## **Uniform provisions concerning the approval of Road Illumination Devices (lamps) and systems for power-driven vehicles**

What the **Unique Identifier** mark is intended to replace ?

Example 1c APPROVAL MARK OF A SINGLE ROAD ILLUMINATION DEVICE

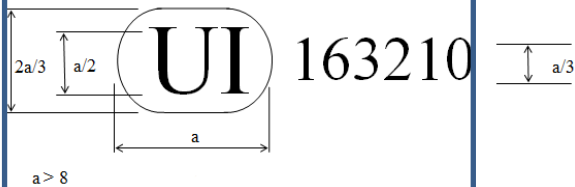
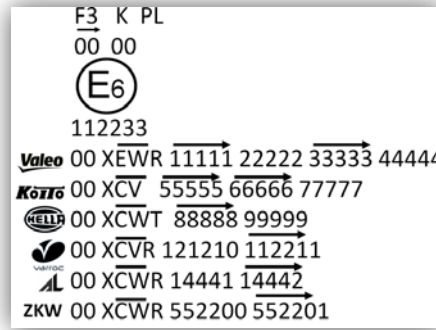
**ALL this marking shall be visible when the lamp is fitted on the vehicle**

**IF the minimum size**

The only visible part of the device when the lamp is fitted on the vehicle is the lens (80% optical area) Ø60mm
